STATE OF DELAWARE
DEPARTMENT OF TRANSPORTATION
800 BAY ROAD
P.O. Box 778
DOVER, DELAWARE 19903

RE: Agreement No. 1945F
Project Number T202369005
Traffic Impact Study Services
Task 17-8 DHCI – New Hospital TIS

Johnson, Mirmiran, and Thompson (JMT) has completed a review of the Traffic Impact Study (TIS) for the DHCI – New Hospital development which was prepared by Davis, Bowen & Friedel, Inc. dated May 2024. This review was assigned as Task Number 17-8. The report is prepared in a manner generally consistent with DelDOT's *Development Coordination Manual* and other Department standards.

Recommendations Map

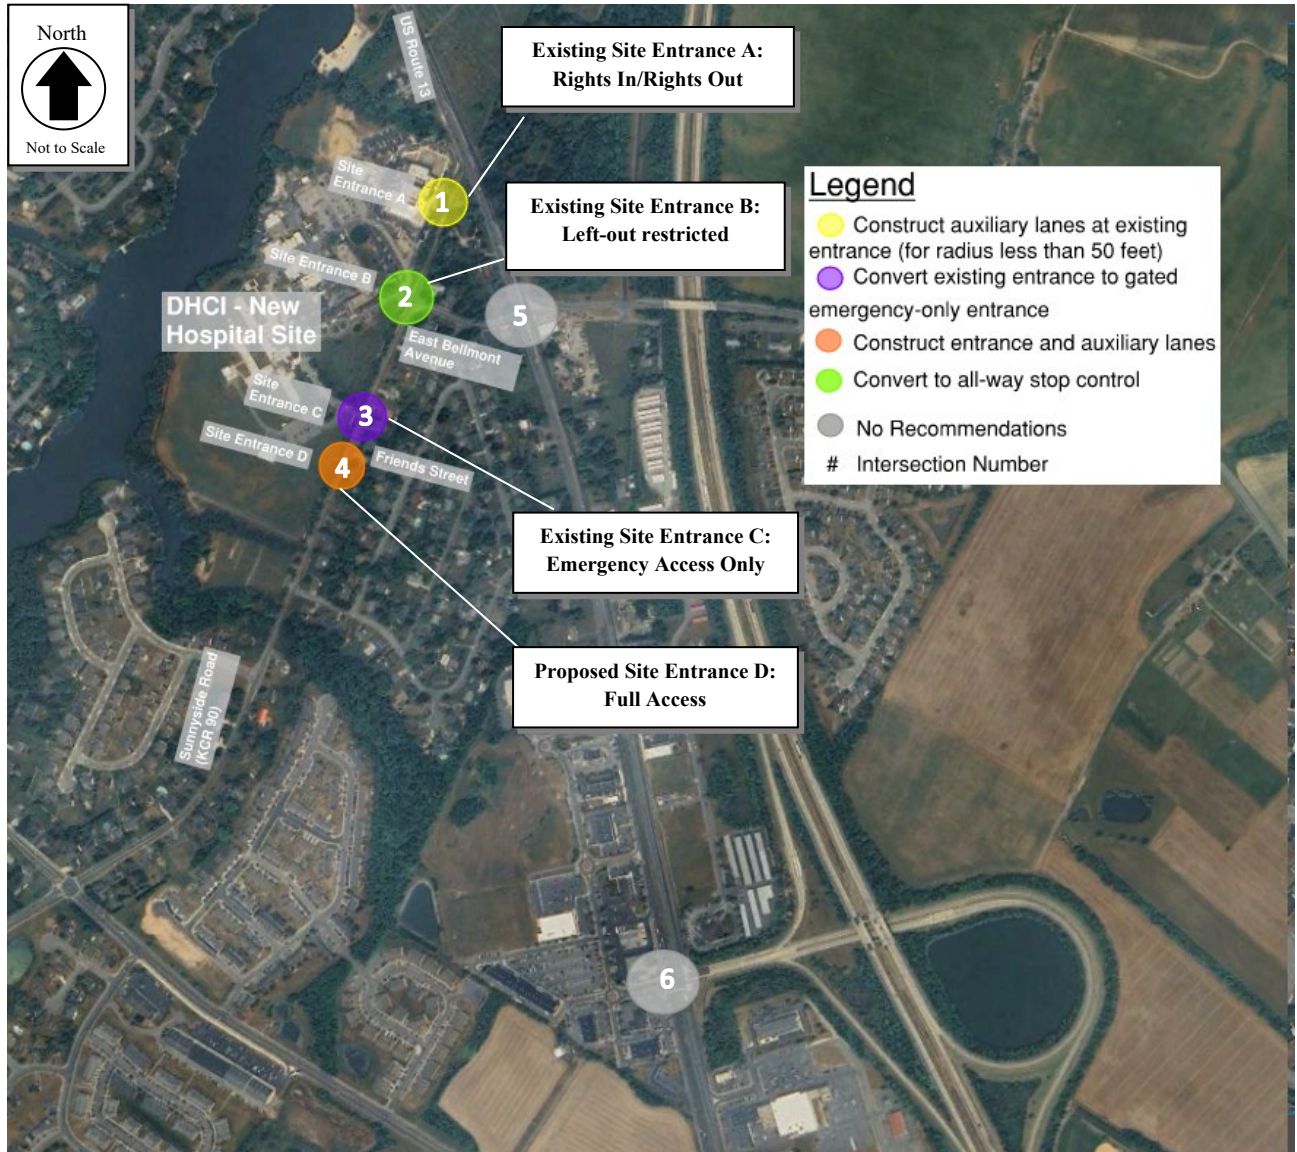
2. The developer should install a westbound right turn lane at the existing unsignalized Site Entrance A rights-in/rights-out only access for the proposed DHCI – New Hospital development along Sunnyside Road, approximately 250 feet west of US Route 13. The intersection should be consistent with the lane configurations shown in the table below.

3. The developer should coordinate with the Town of Smyrna and DelDOT Traffic on the implementation of converting the existing unsignalized Site Entrance B access along Sunnyside Road, across from East Belmont Avenue, to an all-way stop-control (AWSC). The existing lane configurations at the intersection would be maintained.

4. The developer should maintain the existing unsignalized Site Entrance C access for the proposed DHCI – New Hospital development along Sunnyside Road and restrict the entrance to be emergency access only. The developer should physically restrict the entrance to be emergency access only based on the treatment determined by the Development Coordination Section during the Entrance Plan review.

5. The developer should construct an unsignalized Site Entrance D access for the proposed DHCI – New Hospital development along Sunnyside Road, across from Friends Street. The intersection should be consistent with the lane configurations shown in the table below.

6. The following bicycle, pedestrian, and transit improvements should be included:
- a. An internal connection from the existing sidewalks into the site should be provided.
 - b. ADA-compliant curb ramps and marked crosswalks should be provided along the site entrances.
 - c. Minimum five-foot wide bicycle lanes should be incorporated in the right turn lane and shoulder along the Sunnyside Road approaches to the site entrances.
 - d. Utility covers should be moved outside of any designated bicycle lanes and any proposed sidewalks or should be flush with the pavement.
